PROPOSED S4.55 CHANGE LIST

Project Name
Castlecrag Quadrangle

Drawing Title
BASEMENT 01 PLAN

Drawing No
A10-0900

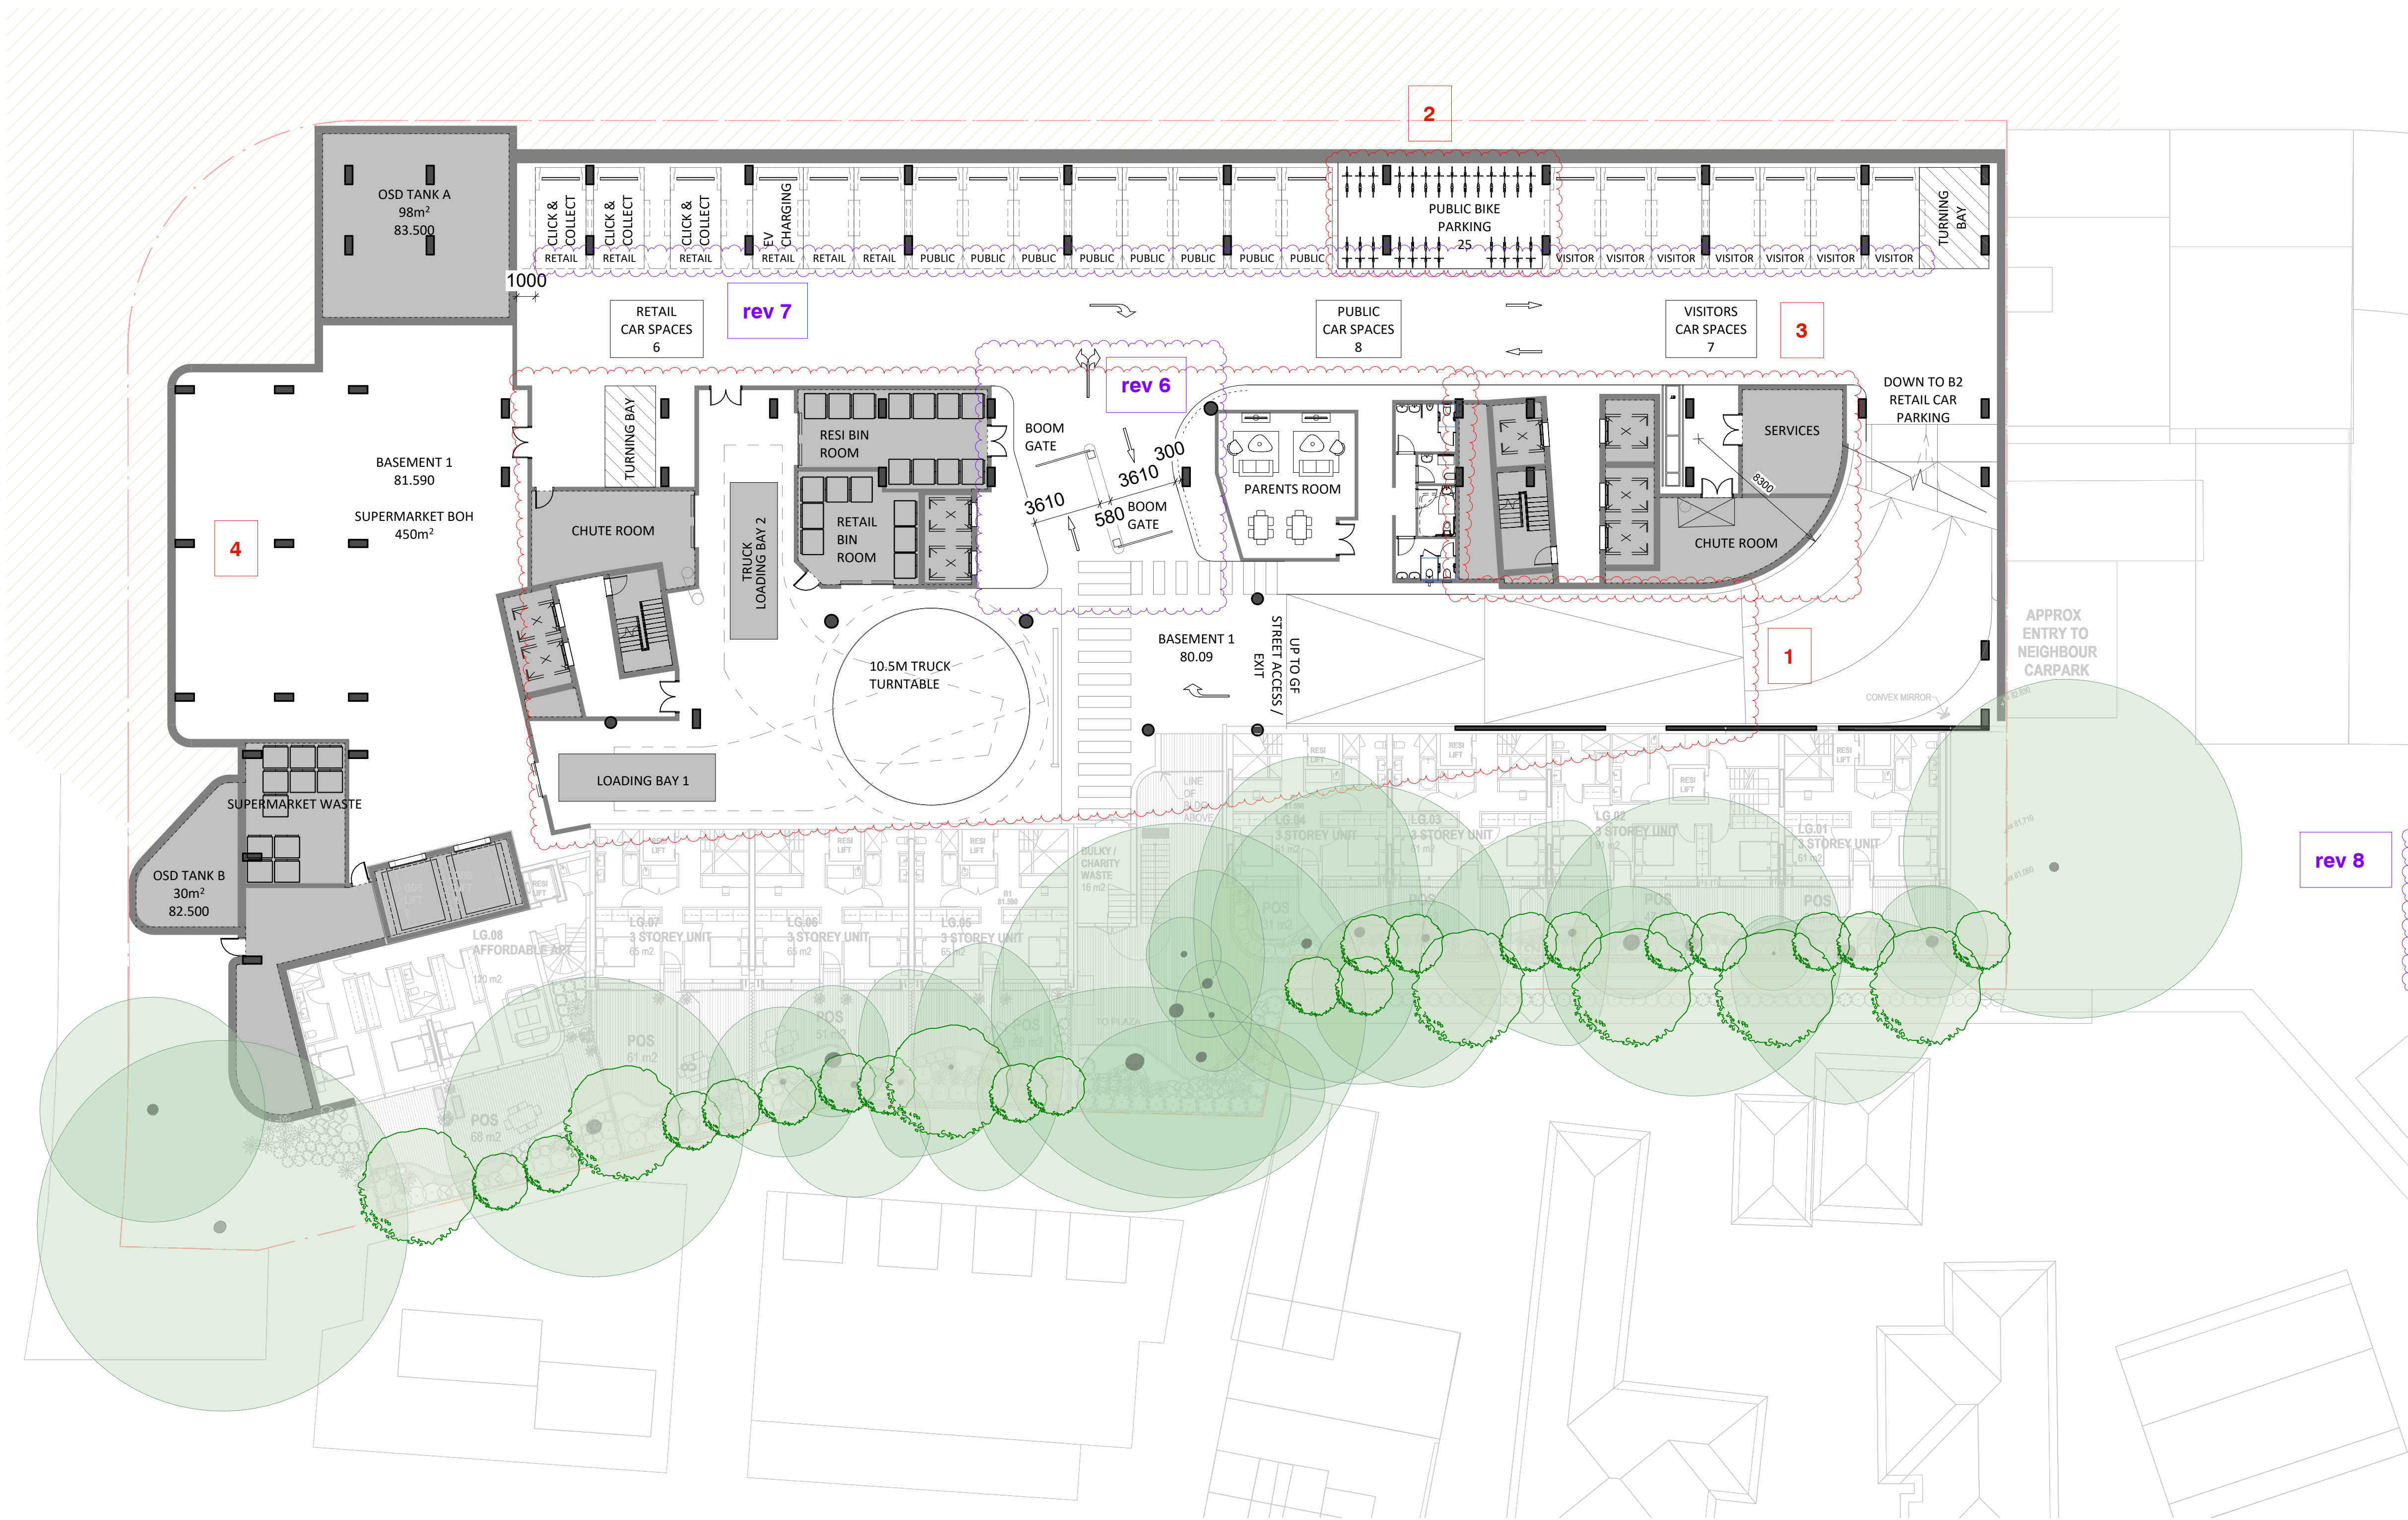
1. LOWERING THE SLAB LEVEL OF THE DA APPROVED BASEMENT 1 TO IMPROVE OPERATIONAL EFFICIENCY, FUNCTIONALITY AND DURABILITY FOR USERS. TRUCK OVERHEAD CLEARANCE LEVELS UNDERSLAB INCREASED TO ENSURE COMPLIANCE. RAMP DOWN TO LB1 INCREASED, LOADING DOCK PUSHED TO THE LEFT AND BOOM GATES RELOCATED TO ALLOW SPACE FOR RAMP.
2. PUBLIC BIKE PARKING PROVIDED HERE NEAR TOILET FACILITIES AND RETAIL ACCESS AREA
3. PARENTS ROOM INCLUDED HERE FOR ADDED FACILITY AMENITY
4. COLUMNS INCLUDED AFTER INITIAL CO-ORDINATION WITH THE STRUCTURAL ENGINEER. BASEMENT PERIMETER COLUMNS NEEDED.
